NEW HEADLIGHT COVERS AND ATV MAINFRAME REVISION

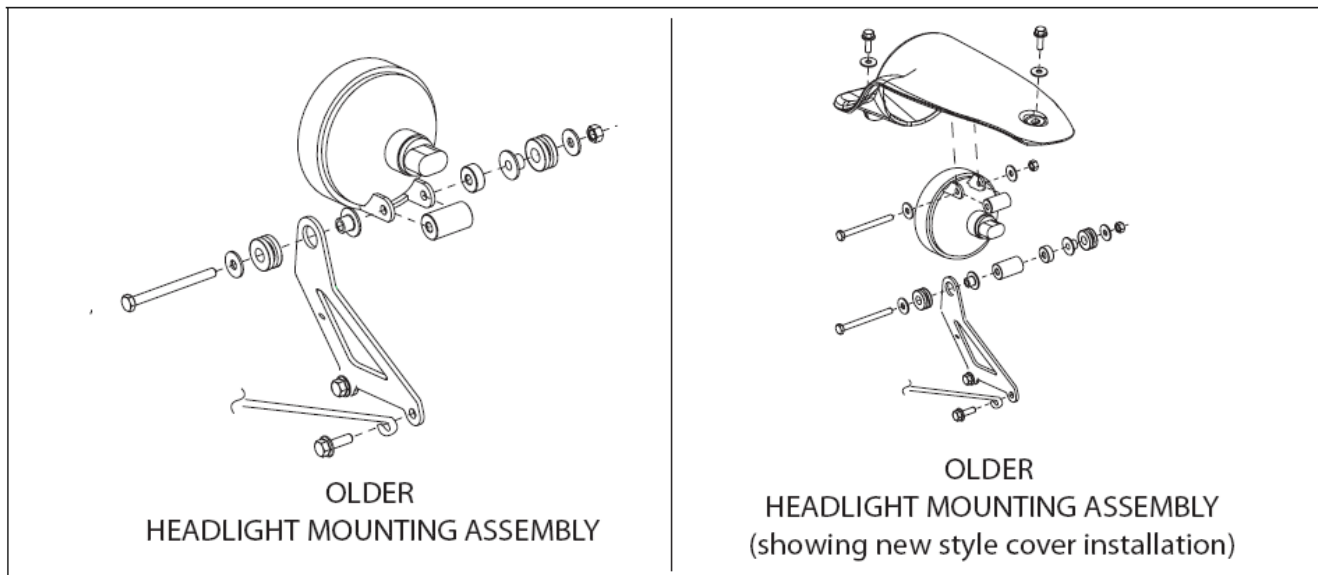
A new style headlight cover is now in production. The new covers (left/right) have integrated headlamp housing mounting tabs. See below right. The older style headlight covers did not have the integrated mounts; the headlamp housing was mounted to a bracket assembly attached to the main frame. The older style covers have been discontinued and are no longer available. At the same time the new covers entered production, a new ATV mainframe entered production. It uses the new covers and does not have the old bracket assembly. To install the new covers on older ATV frames, the headlamp must be removed from the mounting assembly (see below left) and installed in the cover. The new covers come with the hardware necessary to mount the removed headlamp housing in the cover.

To install the newer headlight covers on older ATV mainframes (ones with headlight bracket assembly depicted below left), - the original headlight mounting assembly must be reassembled (minus the headlamp housing) and the nut tightened securely. If the assembly is not reassembled, the small tab securing the fender bracket to the frame can break off. The small frame tab of older ATVs is supported by the "triangulation" of the headlight mount assembly. If its not reassembled and tightened securely, the tab can break off.

The frame tab on newer ATV frame is different and does not require the extra support.
